UNITED STATES PATENT AND TRADEMARK OFFICE

10/611,978

Office Action Summary

Final Rejection***Election/Restrictions***

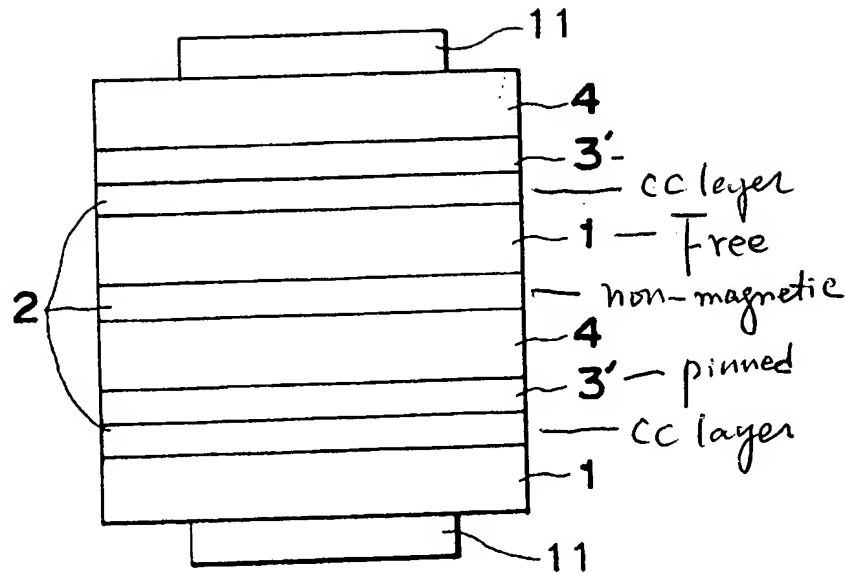
Claim 1, Sakakima et al shows a CPP spin-valve element with two electrodes 11 and 11 (Column 3, line 20) formed on an inherent substrate (See Fig. 5 attached above and column 5, lines 4 – 49) including: a free layer structure including at least one ferromagnetic layer; a pinned layer structure including at least one ferromagnetic layer, the free layer is magnetically softer than the pinned layer (column 4, lines 376-39); a thin non-magnetic spacer layer structure configured to separate the free layer and the pinned layer to prevent a magnetic coupling between the free and pinned layer structures, and to allow an electric current to go there through; and wherein at least two current-confining (CC) layer structures 2 including at least two parts 21 and 22 having significantly different current conductivities (Fig. 2A and 2B, column 3, lines

Claim 8, Sakakima et al further shows in Fig. 5 attached above that one of the CC-layer structures is located in the vicinity of the free layer structure, and another of the CC-layer structures is located in the vicinity of the pinned layer structure.
